STAFF RECOMMENDATION

1011 South Douglas Avenue
January 16, 2019

Application: New Construction--Addition
District: Waverly-Belmont Neighborhood Conservation Zoning Overlay
Council District: 07
Map and Parcel Number: 10513017100
Applicant: Dustin Murphy, Bonadies Architect
Project Lead: Paul Hoffman, paul.hoffman@nashville.gov

Description of Project: This application is for new construction of an addition to the existing house. The addition as designed will mirror the house in height, width and footprint.

Figure 3: Sanborn map shows that the building did not have an associated outbuilding as late as 1957.

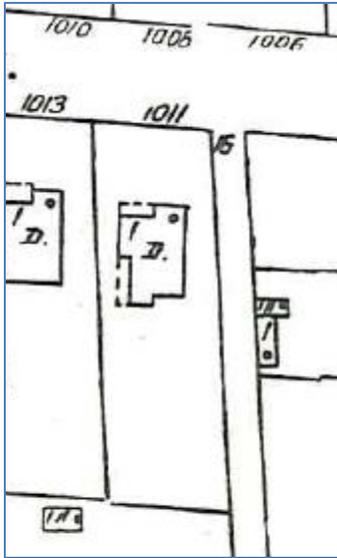
Demolition: An existing outbuilding is to be demolished. The date of construction is unknown, but it was constructed sometime after 1957 as it does not show up on the 1957 Sanborn map. (See Figure 3)

Because of its age of construction its removal meets section V.B.2 for appropriate demolition.

Figure 7. Window and door openings on left side proposed to be altered

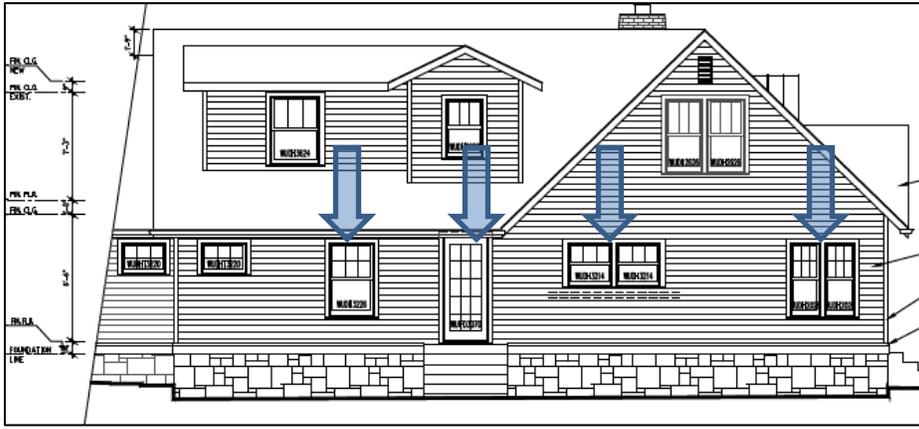
On the left side, the existing door is proposed to be moved approximately to the midpoint of the house, and two new windows added at the rear of that side. The relocation of the door to this opening may be appropriate, as there is an existing window opening in this location. In general, the Commission has approved window alterations to the rear of the midpoint, but has not approved alteration of visible window openings toward the front of a contributing building. As historic imagery shows that the window sets toward the front of this facade are likely original windows (Figure 5), Staff recommends that the window openings forward of the midpoint not be altered.

5. Before removing the front porch roof, the applicant submit photographic or construction evidence that this feature is not original;
6. The existing window openings forward of the midpoint on the left side not be altered;

front elevation - unit a

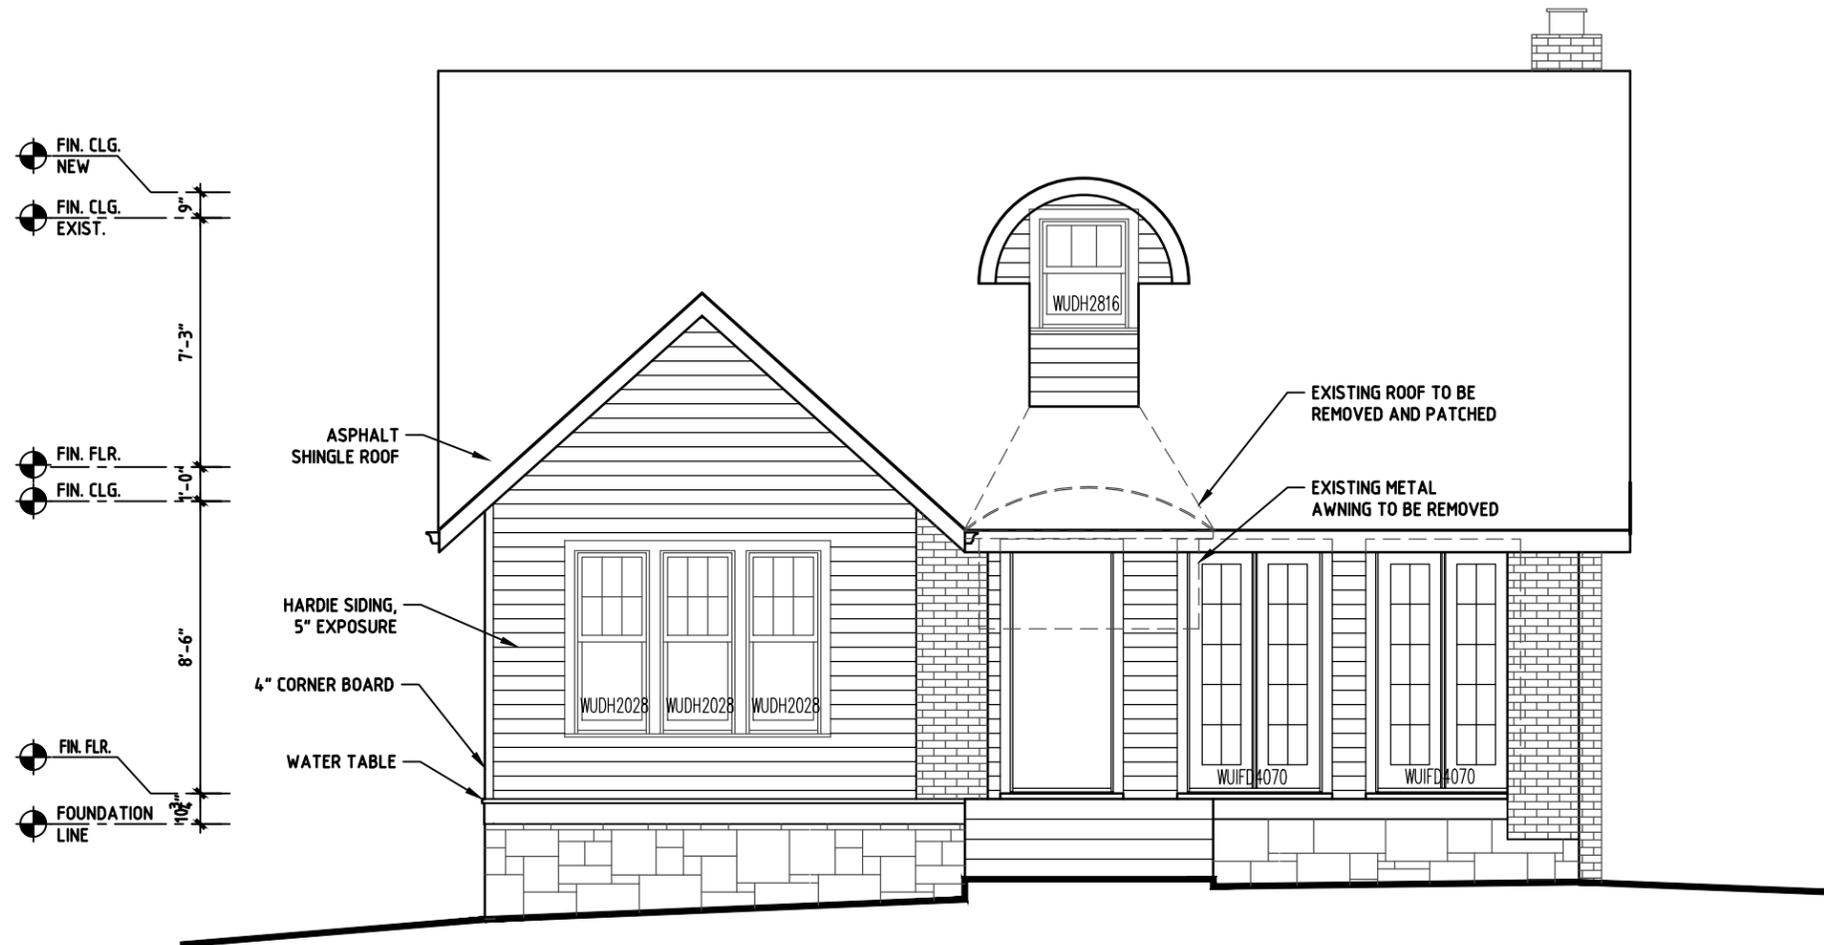
A non-historic metal awning over the front porch is proposed to be removed, and the barrel-vaulted roof over the front entry is proposed to be removed and replaced in plane with the existing front roof. It is unclear if the barrel-vaulted section is an original or early feature of the house, and an earlier photo (Figure 4) does not show this part of the house clearly. Before removing this roof feature, which could be a character-defining feature, Staff recommends that the applicant determine through photographic or construction evidence if it is an historic feature of the house.

neighbor elevation

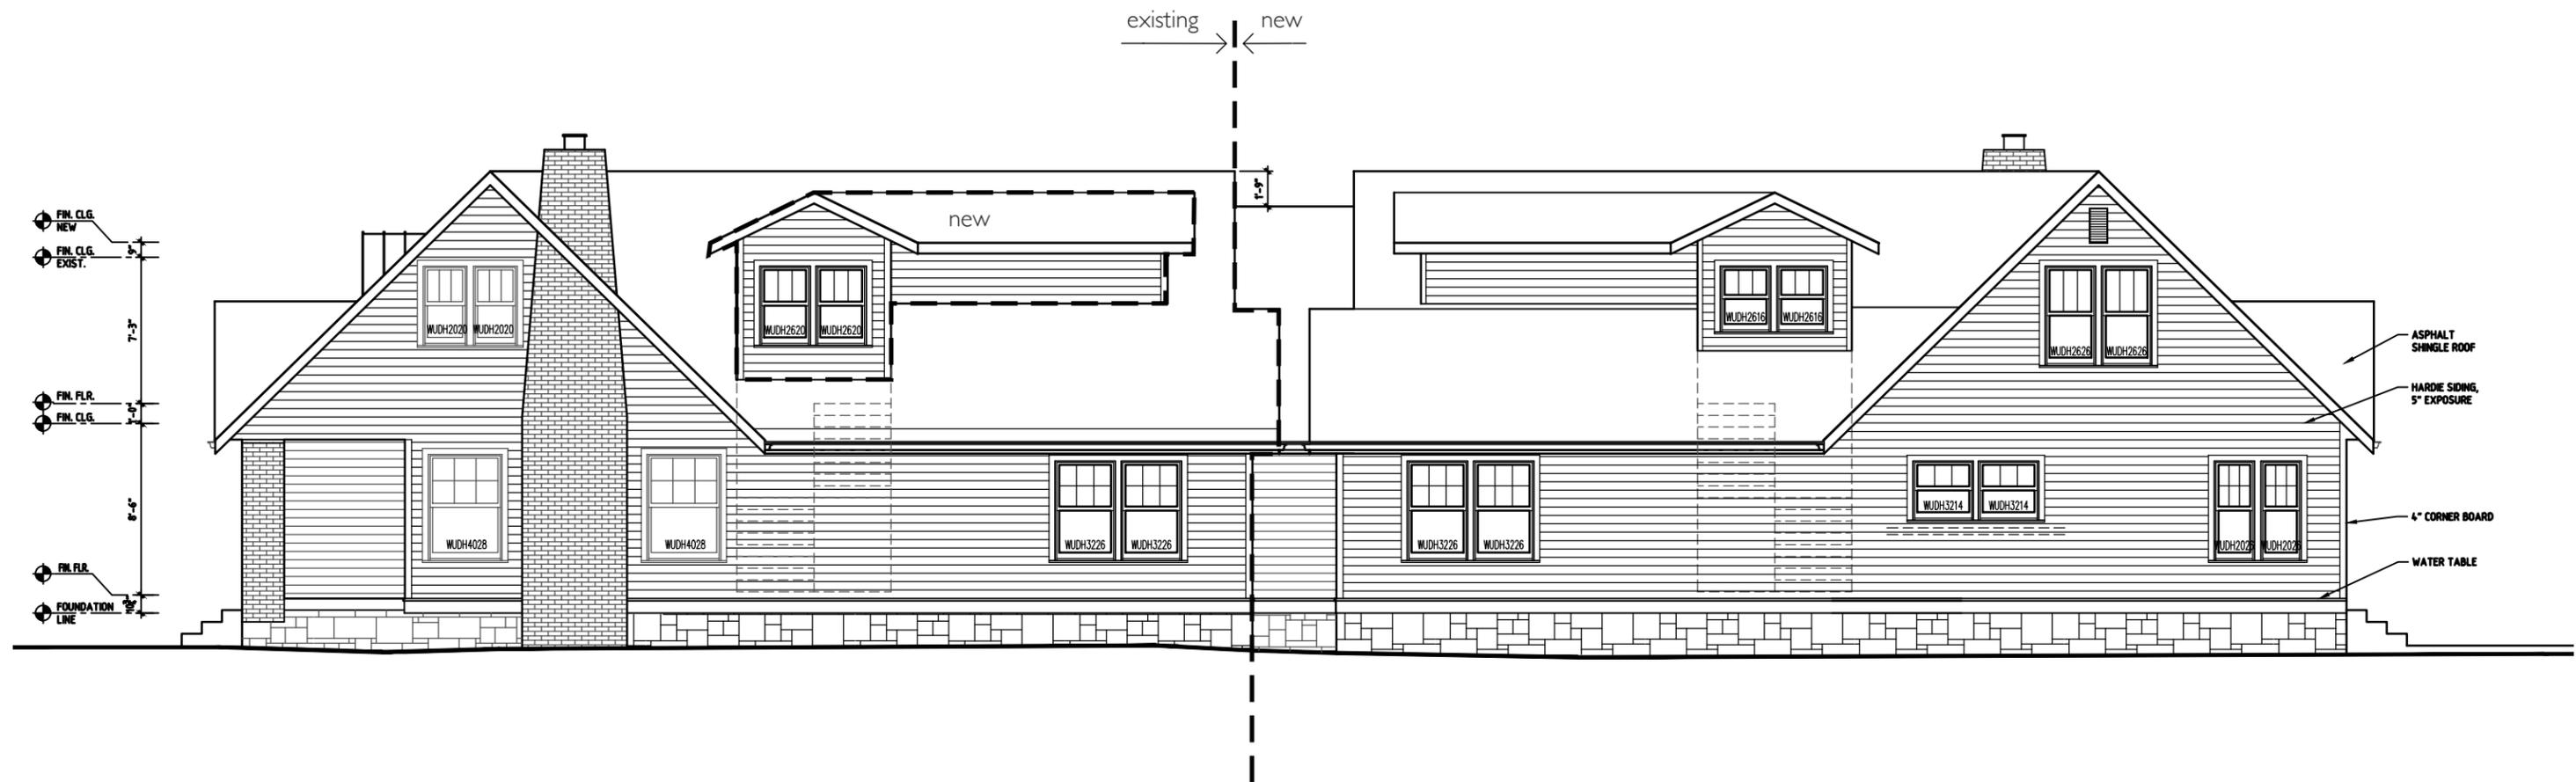
Figure 11. The proposed dormer on the right side of the addition is not appropriately scaled or glazed.

On the right side of the house, a portion of the dormer is a traditionally scaled, gabled, and glazed dormer but with a long projection of a different proportion and with no glazing. Staff recommends a dormer or dormers that are traditionally scaled and glazed. There are a number of options; therefore, Staff hesitates to provide a specific recommendation.

3. That the number of dormers on the historic building should not exceed more than two on each side;
4. The addition's left dormer face be fully glazed or that the long dormer be broken up into two dormers that are primarily glazing; and the right side dormer be a dormer or dormers that are traditionally scaled and glazed;

alley elevation

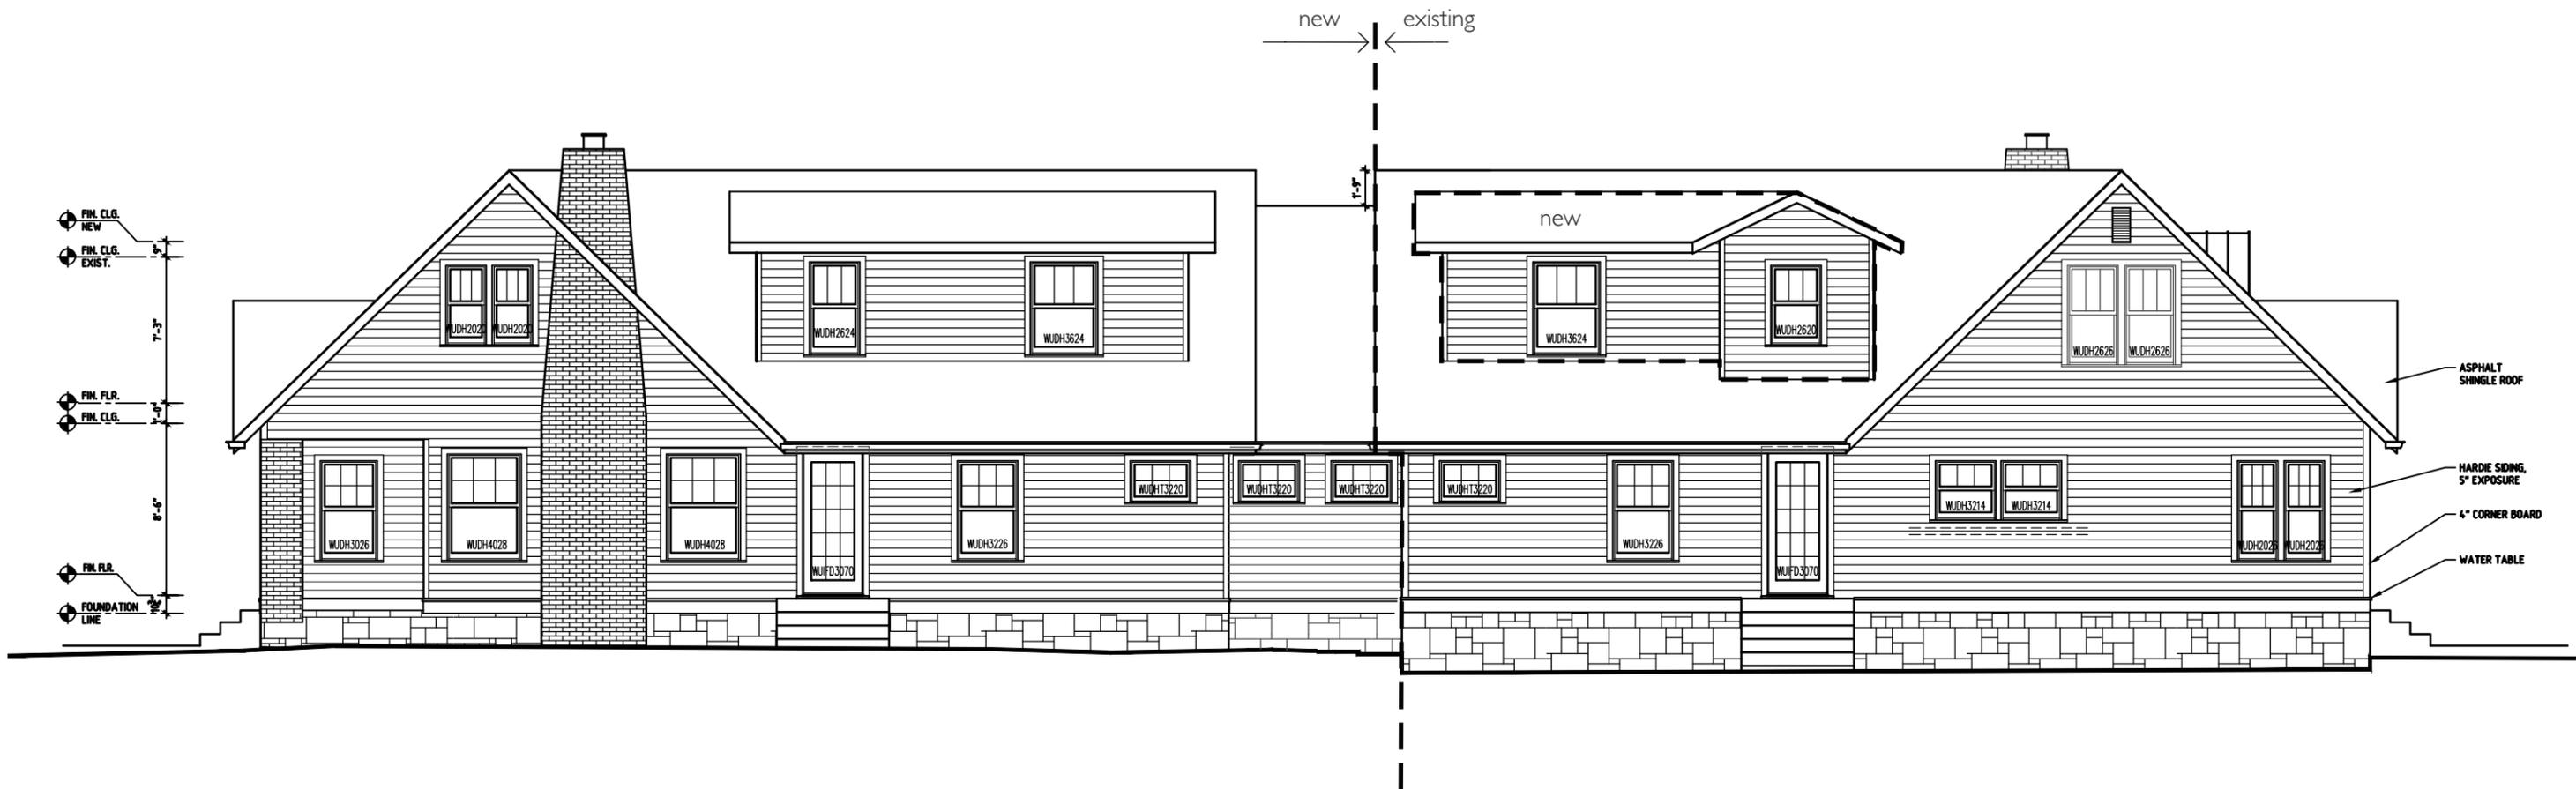
Figure 10. The east/alley side shows the addition to the left and the existing house on the right.

In the past, the Commission has allowed for larger dormers on an addition than those that are considered appropriate as rooftop additions to a historic building but have asked that the face of dormers be fully glazed. On the left side of the house, the addition has a long shed roof dormer with two windows. (See image 6.) Although the shed roof form isn't found on this particular house, it is found in the historic district; therefore, staff finds it to be appropriate for an addition. Staff recommends that either the face be fully glazed or that the long dormer be broken up into two dormers that are primarily glazing on the face.
